SAN ANTONIO WATER SYSTEM
CRESCENT PARK BOOSTER
STATION PROJECT
SAWS Job No. 12-6006
SAWS Solicitation No. B-12-043-CM

ADDENDUM NO.3
October 26, 2012

SAN ANTONIO WATER SYSTEM
CRESCENT PARK BOOSTER STATION
GATE ELEVATION & DETAILS
SAN ANTONIO, TEXAS

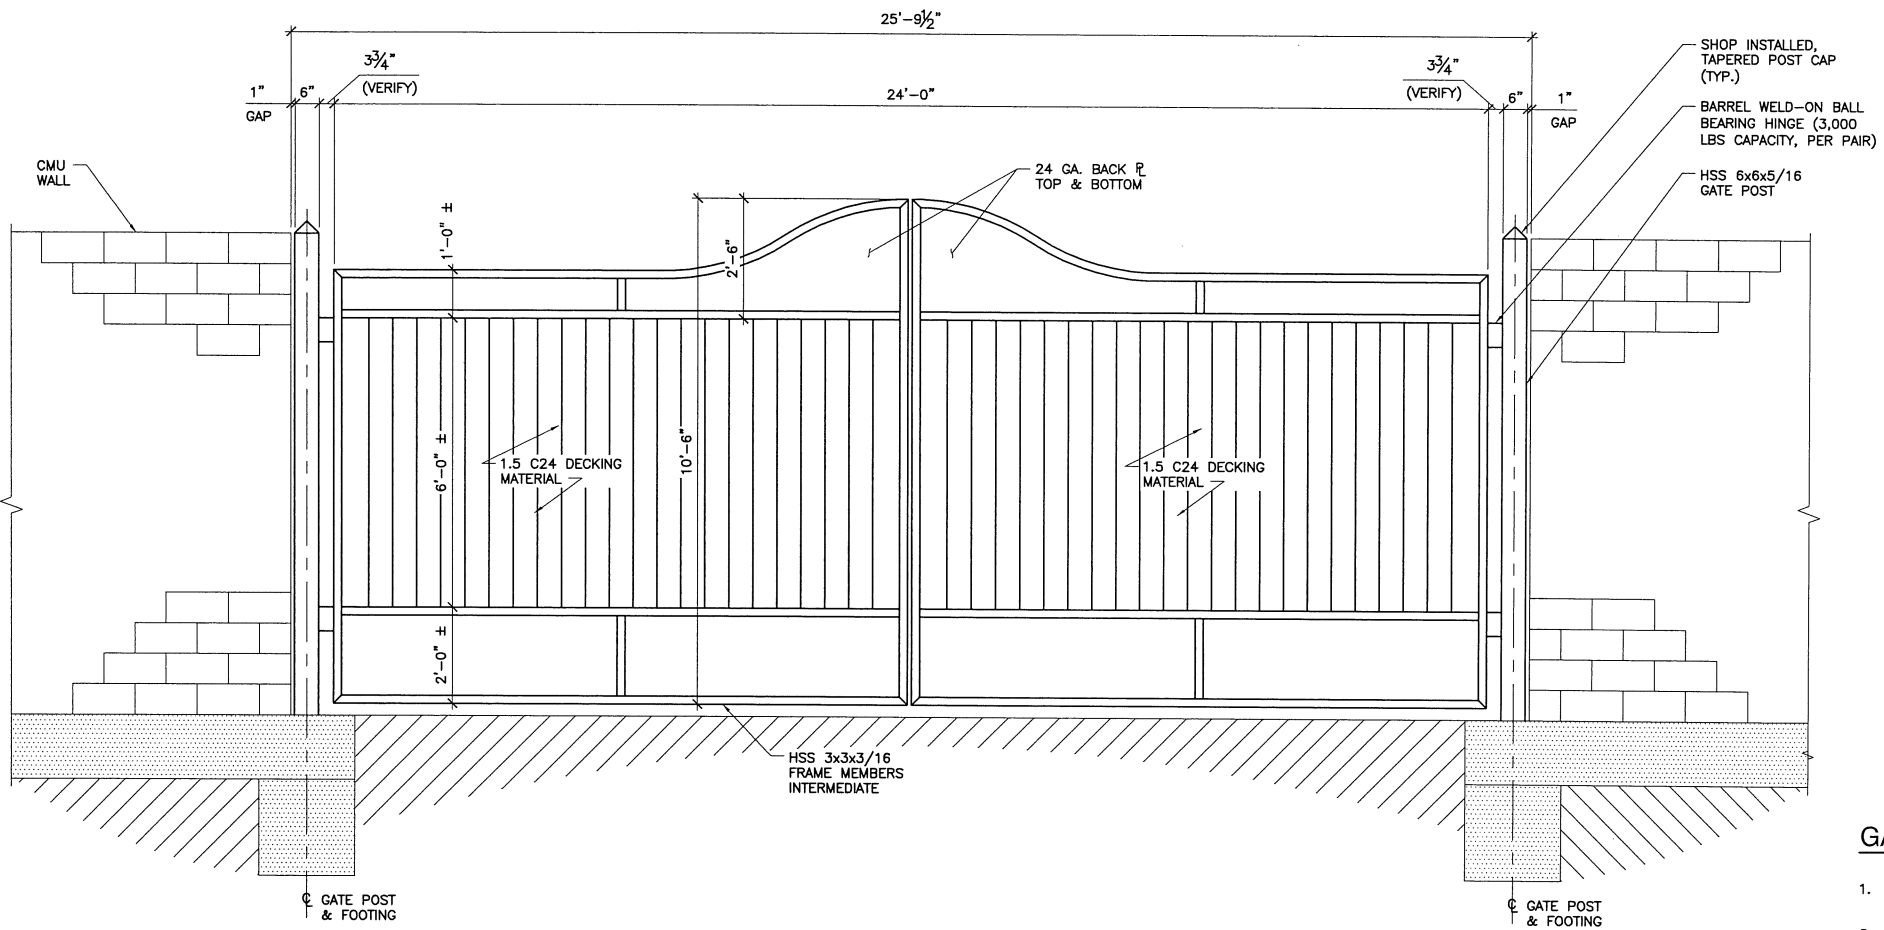
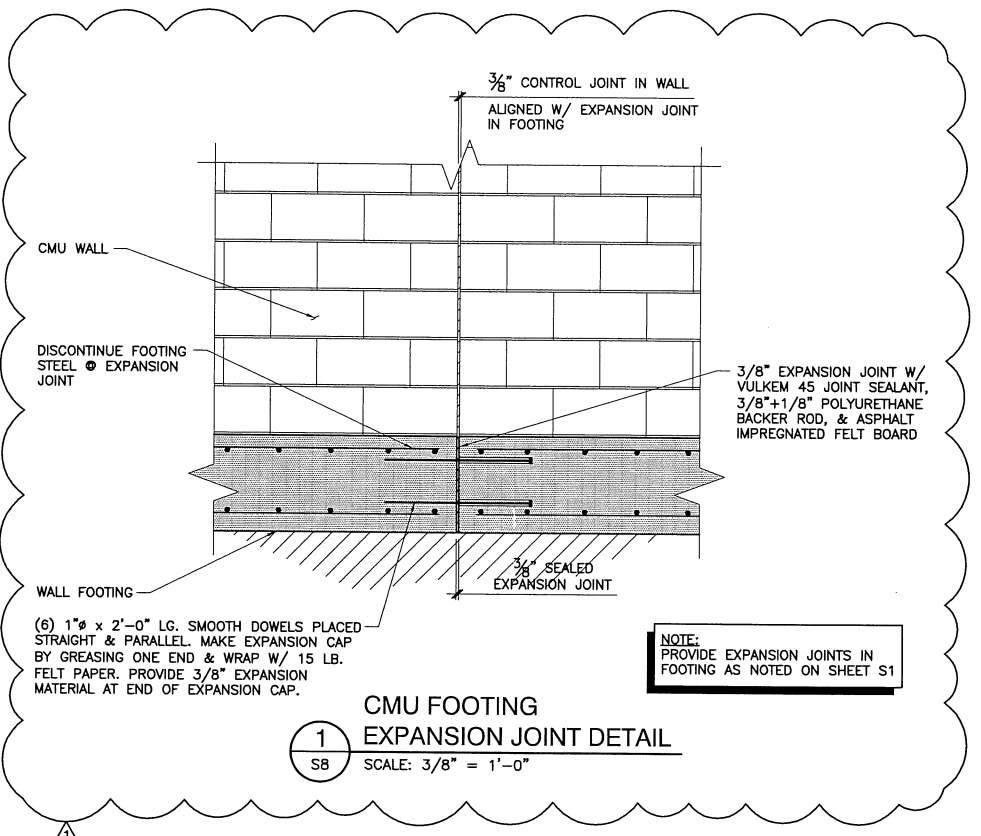
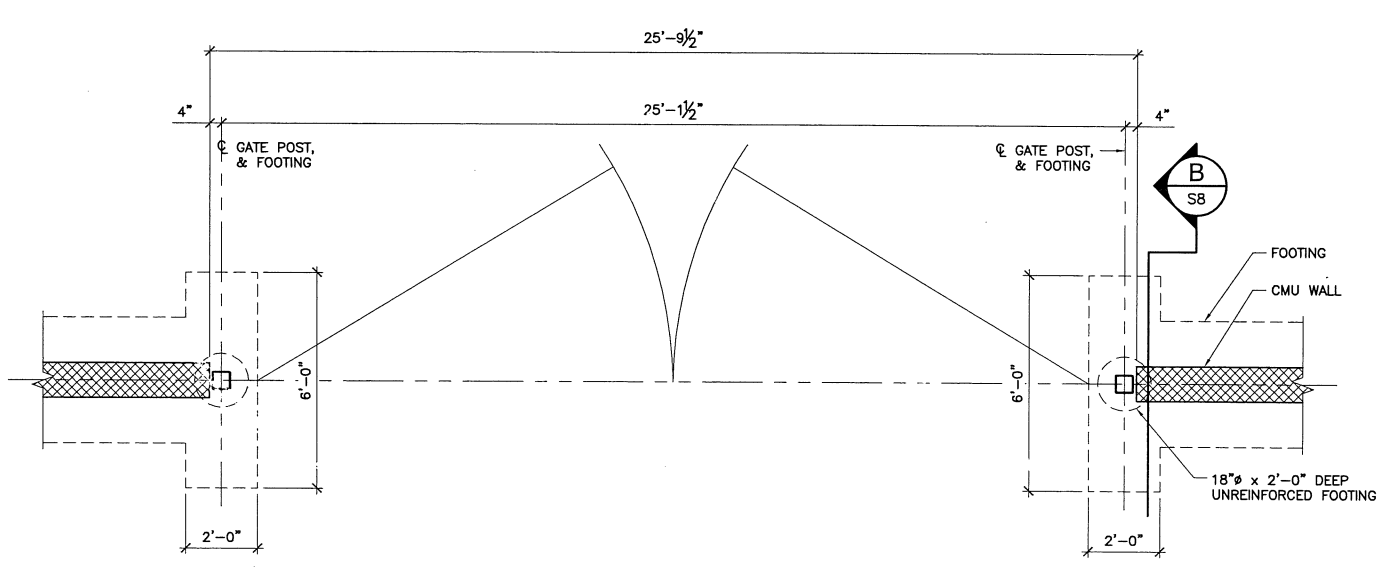
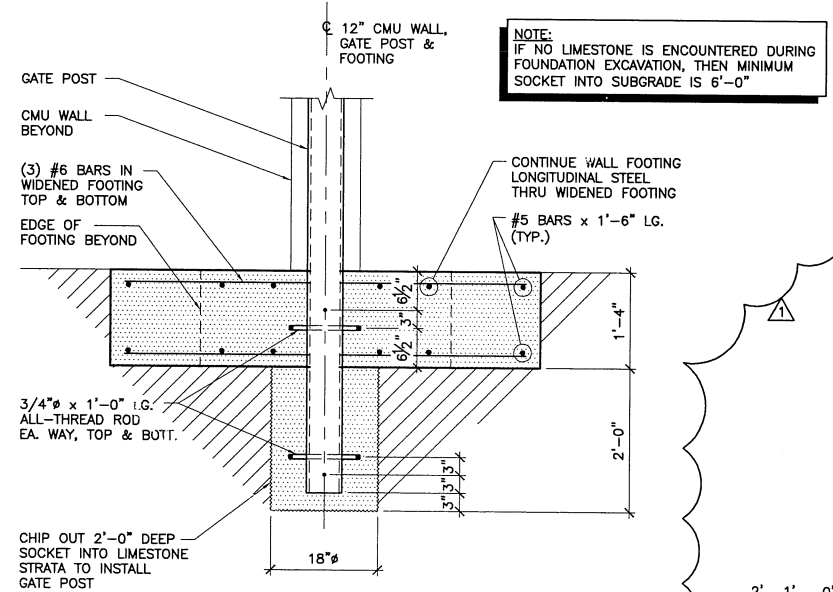
- A11: *The details for the wall have been included in this Addendum. See Attached Sheets S1, S7, and S8.*
- Q12: The bid form and the drawings call for a 10' security wall and a gate, but I can't find any other information or a specification on this wall. Can we get a specification and/or a detail drawing giving the contractors more information on this item?

- A18:** *The third condition in Section 15500.24(2)(C) is correct as written.*
- Q19: Please provide a detail for the security wall around the site.
- A19:** *The details for the wall have been included in this Addendum. See Attached Sheets S1, S7, and S8.*
